Member of Entropy Nuclear Vermont Yankee LLC
 Docket No. 50-271 Official Exhibit No. NEC-RH-05
 OFFERED by: Applicant/Licensee (Intervenor) NEC
 NRC Staff Other _____
 IDENTIFIED on 7/23/08 Witness/Panel Hausler
 Action Taken: ADMITTED REJECTED WITHDRAWN
 Reported Clerk MAC

**Flow Assisted Corrosion (FAC) and Flow Induced Localized Corrosion:
 Comparison and Discussion**

The direct testimony by Dr. Jeffrey S. Horowitz and Dr. James C. Fitzpatrick¹⁾ with regards to NEC Contention 4 – Flow Accelerated Corrosion has raised a number of questions, which are being discussed below:

Figure 1

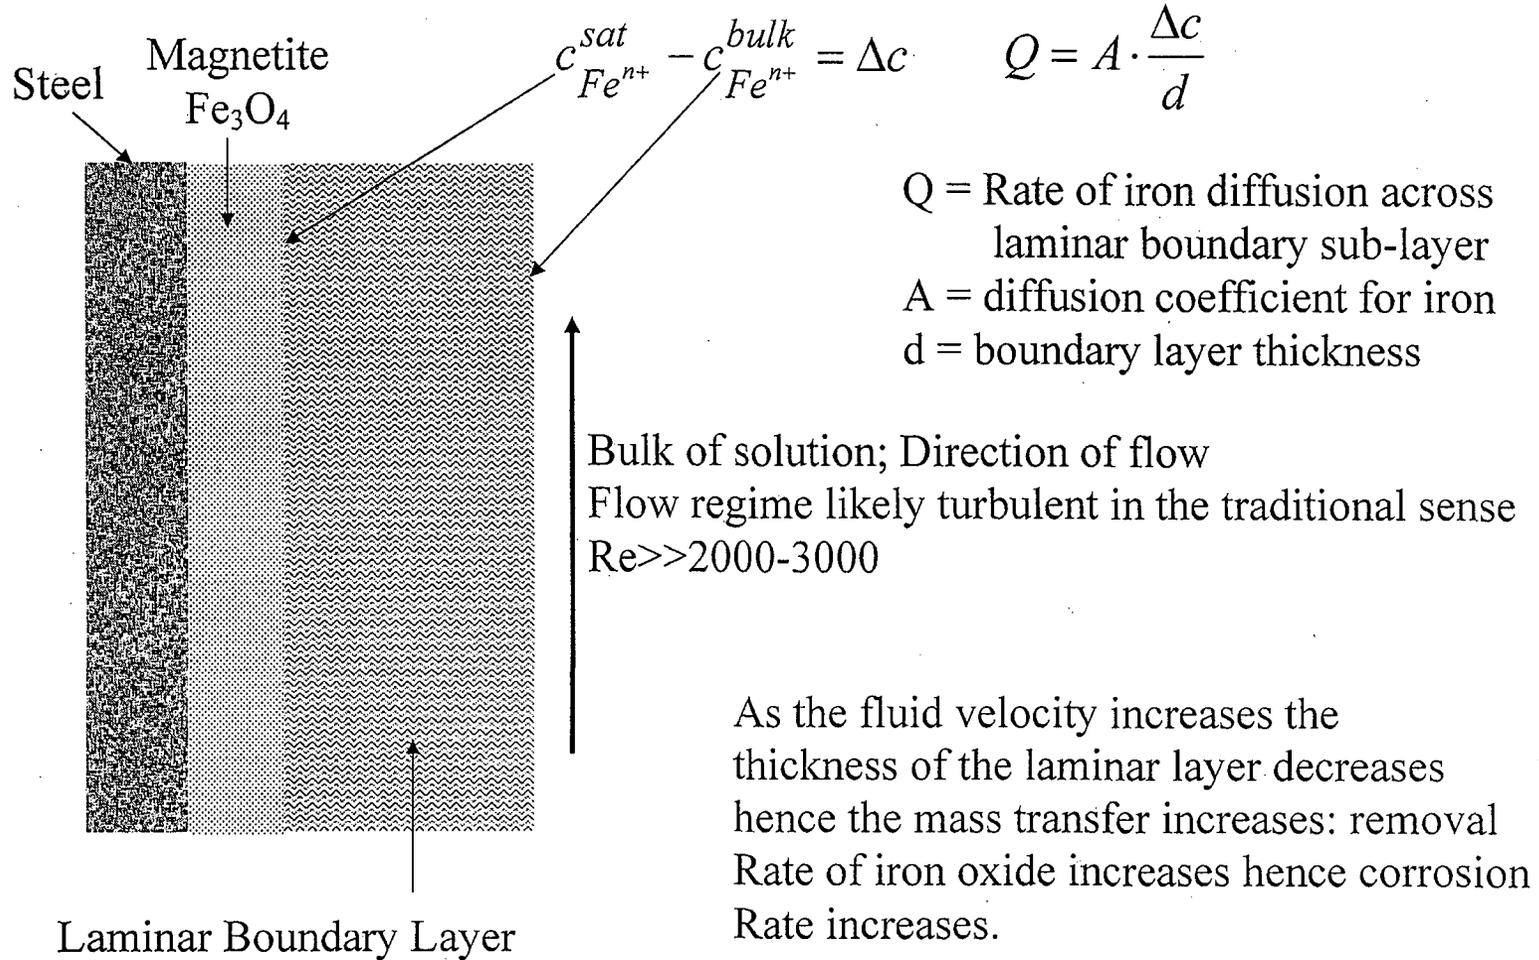
the magnetite surface across the stagnant boundary layer. The solubility of iron (from magnetite) is very, very low. Hence, the mass transfer of iron ions across the stagnant water layer near the magnetite surface, which occurs by diffusion and is controlled by the concentration gradient, is very low as well. The thickness of the stagnant layer, which is infinite if there is no flow, is reduced as flow over the surface increases. Therefore, as the flow [rate] over the surface increases, the stagnant layer (also called the laminar boundary layer or the diffusion layer) is reduced in thickness, the diffusion rate increases, and hence the dissolution rate of the passive layer. The thickness of the passive layer (which is very small to begin with) becomes a steady state value when its formation rate (the corrosion rate) equals the removal rate (dissolution and mass transfer rate). The latter is controlled by the flow rate.

Therefore, this type of corrosion has been termed Flow Assisted Corrosion (FAC). However, as we will see below, the fact that the creators of Checworks have decided that the main characteristic of FAC is its proportionality to the flow rate is entirely arbitrary.

Figure 2

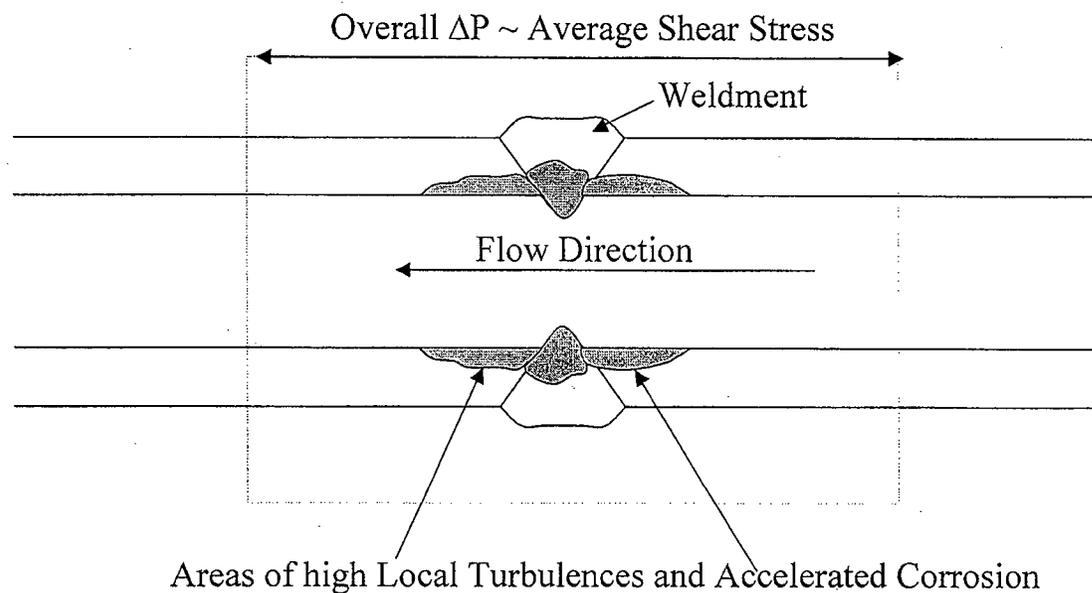
The different paradigms can perhaps be explained by means of Figure 2 (below). Any geometric feature in a flow channel (pipe for instance) that reduces or expands the [hydraulic]-diameter, or changes the direction of flow, creates a flow disturbance (including sensors inserted into the pipe for temperature, pressure or other parameters). This means that the flow regime, which in the straight sections of the pipe may be fully developed laminar or turbulent flow changes to one, that also incorporates local turbulences (eddies). This leads to locally enhanced shear stress and hence enhanced mass transfer and therefore locally increased corrosion.

The local shear stress is in no explicit relationship to the average shear stress
And can be orders of magnitude higher depending on geometric factors
